TOLEDO - LUCAS COUNTY PLAN COMMISSIONS

DATE: October 14, 2021

REF: SUP-8003-21

SUBJECT: Special Use Permit for a new gas station and convenience store at 3531 Airport Highway

SITE PLAN

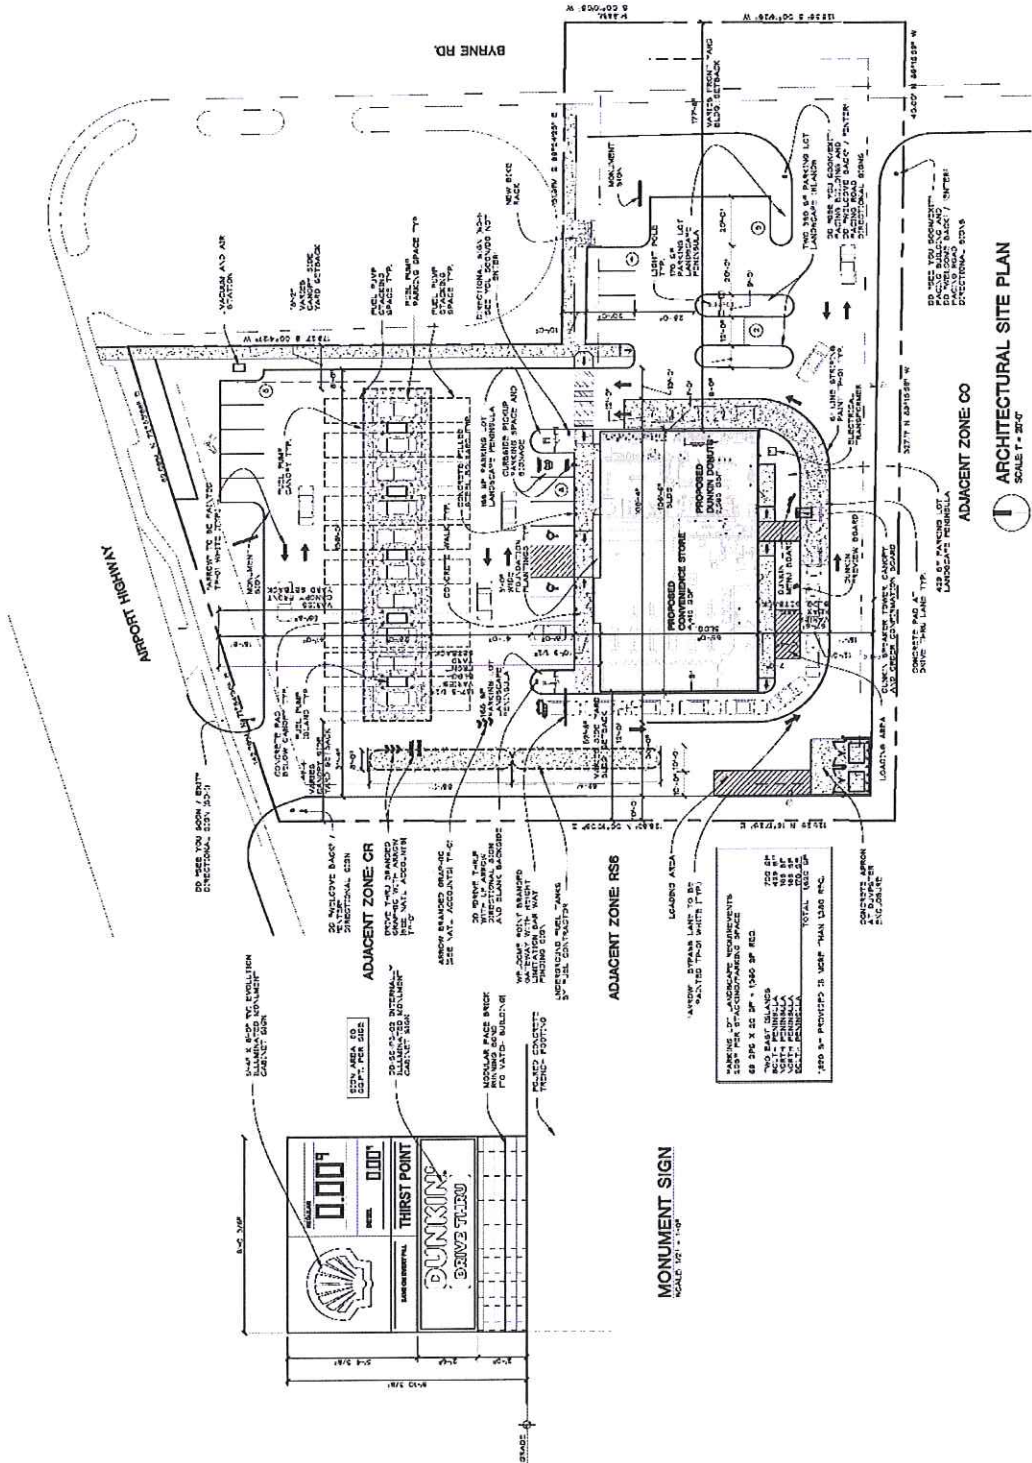
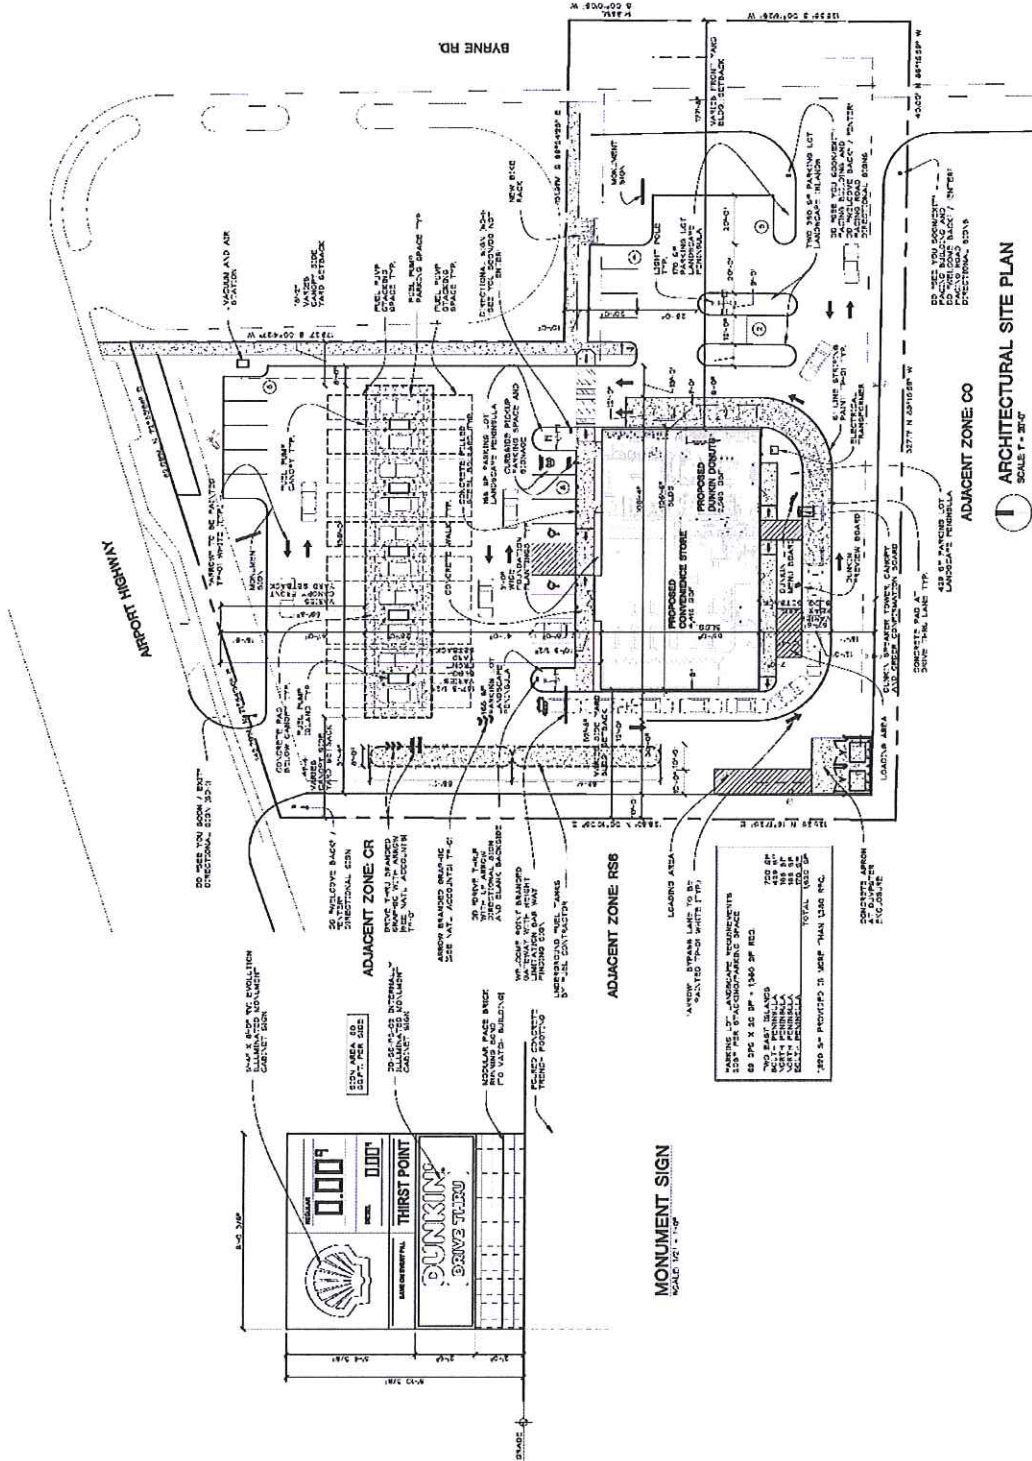
The minimum number of spaces for the site is twenty-nine (39) spaces. The site plan provides thirty-four (34). An alternate parking plan shall be submitted to the Director of the Plan Commission or an additional five (5) spaces shall be provided on the site plan.

Plan Commission Staff commends the submittal of bike parking details. However, bike parking locations shall require adjustments to allow for efficient and safe access to the site.

8. The existing public fire hydrant on Byrne Road shall be shown on the plans. It appears to be in conflict with the proposed driveway. If it indeed is in conflict and must be relocated, it will be relocated by the City of Toledo at the developer's expense.

29. A 25' drive aisle is required for two-way traffic per TMC1107.1900. (Specifically the drive aisle east of light pole in parking area near Byrne Road.)
30. Accessible parking space signage height must be no less than 60" and no more than 72" above pavement level per TMC 1107.1704
31. Transportation recommends the property line be brought into alignment with right-of-way line on Byrne Road.

40. The minimum number of parking spaces for this site as indicated in TMC§1107.0300 – Off-street parking schedule “A” is thirty-nine (39), including parking spaces at gas pumps. The site plan indicates thirty-four (34) parking spaces. **Additional parking shall be provided or an alternate parking plan shall be submitted, reviewed, and approved by staff.**

41. Bicycle parking shall be placed within proximity to the primary entrance of the building to allow for safe use of the facility for cyclists entering the site from either frontage.

- a. A Type “A” Landscape Buffer is required along the adjacent parcel(s) zoned RS6. The buffer shall be at least a six-foot (6') high masonry wall, or similar fencing and screening, designed to be harmonious with other building materials on site, as well as four (4) canopy trees per one-hundred feet (100'). **Revised site plan shall depict masonry wall.**

- b. A Type “B” Landscape Buffer is required along the adjacent parcel(s) zoned CO, which border the southern property line. The buffer shall include at least four (4) canopy trees per one-hundred feet (100') as well as a masonry wall, or similar fencing and screening, at least six feet (6') in height designed to be harmonious with other building materials on site. **Revised site plan shall depict masonry wall.**

- c. Two (2) additional trees within the fifteen-foot (15') frontage greenbelt along Byrne Road. **Not acceptable as depicted.**
 - d. Five (5) additional trees within the fifteen-foot (15') frontage greenbelt along Airport Highway. **Not acceptable as depicted.**

- e. Additional shrubs stretching the entire length of the paved area along Airport Highway. **Not acceptable as depicted.**
 - f. Additional shrubs between the pedestrian path/sidewalk and the paved surface along the portion of the pedestrian path/sidewalk which connects Byrne to the building. **Not acceptable as depicted.**

WEST & SOUTH ELEVATIONS

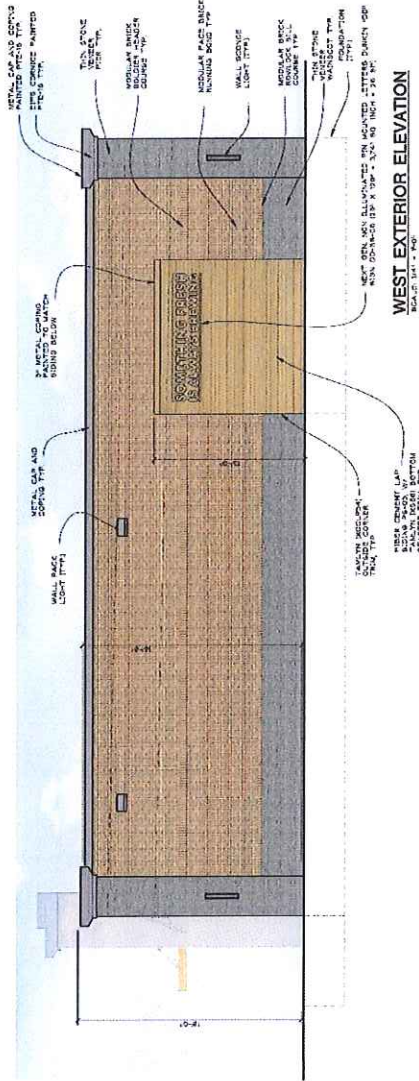
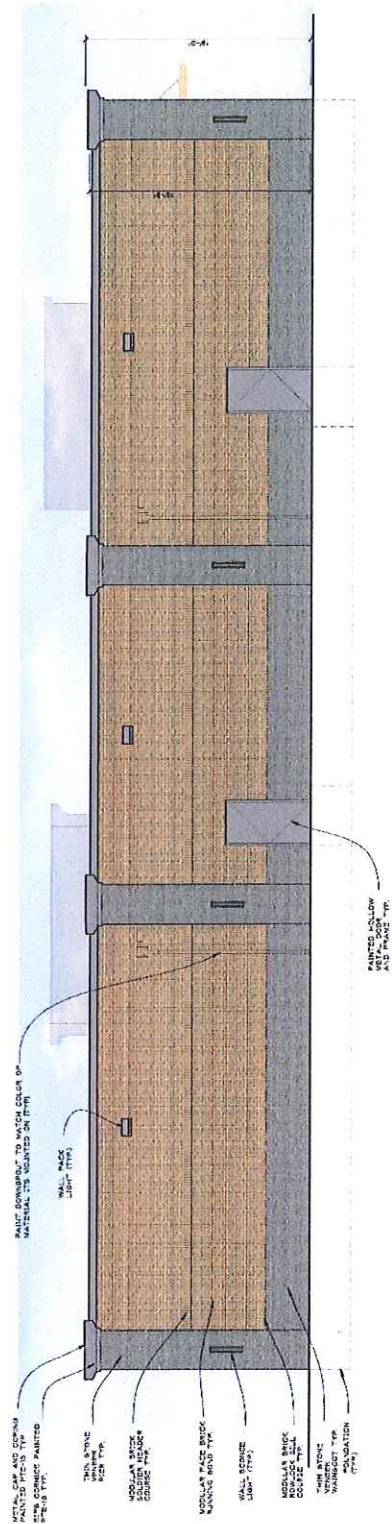
Submitted elevations for the building meet the design standards of TMC§1109 – *Design Standards*. The designers have worked with Plan Commission Staff to create a functional, visually appealing, and compliant building within the geometric constraints of the site. A combination of fiber cement, architectural metals, varied brick patterns, and glass storefronts are used to meet the requirements.

33. Any spaces reserved for the use by persons with physical disabilities shall adhere to the standards outlined in TMC§1107.1700.
34. Elevations shall meet the design criteria of TMC§1109.0501. At least 80% of each elevation visible from the right-of-way shall be composed of predominant materials and no greater than 20% shall be composed of accent materials. The provided elevations utilize glass storefronts, thing-stone veneer, and gray and brown modular face brick as predominant materials – composing greater than 80% of the total elevation. Accent materials used include fiber cement panels and lap siding to vary the mass and visual flow of the building. **Acceptable as depicted.**

18' DUMPSTER ENCLOSURE
ASPPD SCALE 1/8\"/>

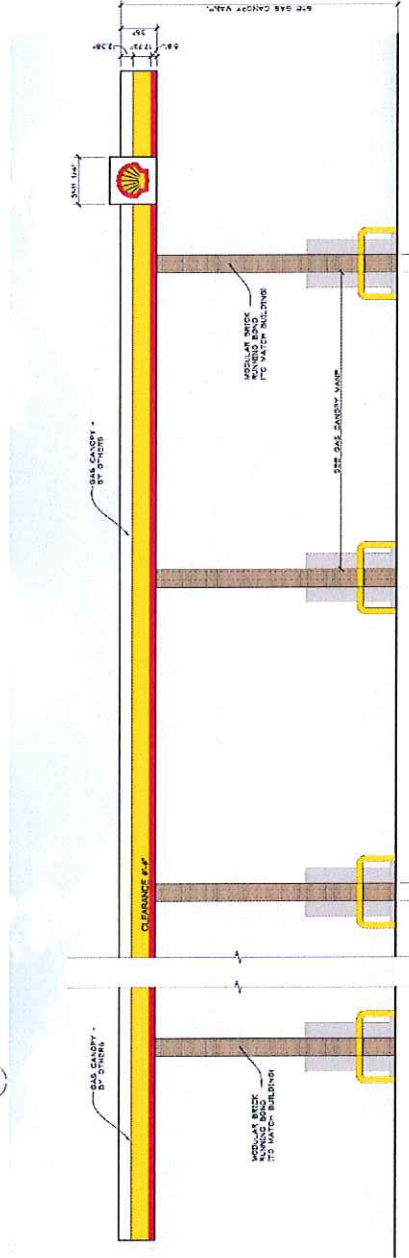
38. Hours of operation are limited to 5:30 am to 1 am, per TMC§1104.0601.
39. Dumpster location(s) shall be clearly defined, have a concrete pad and be surrounded by a solid wooden fence or a masonry screen enclosure with landscaping and shall not be located in any required setbacks or the public right-of-way as stated in TMC§1361.10(b)(10) of the Building Code **Acceptable as depicted.**
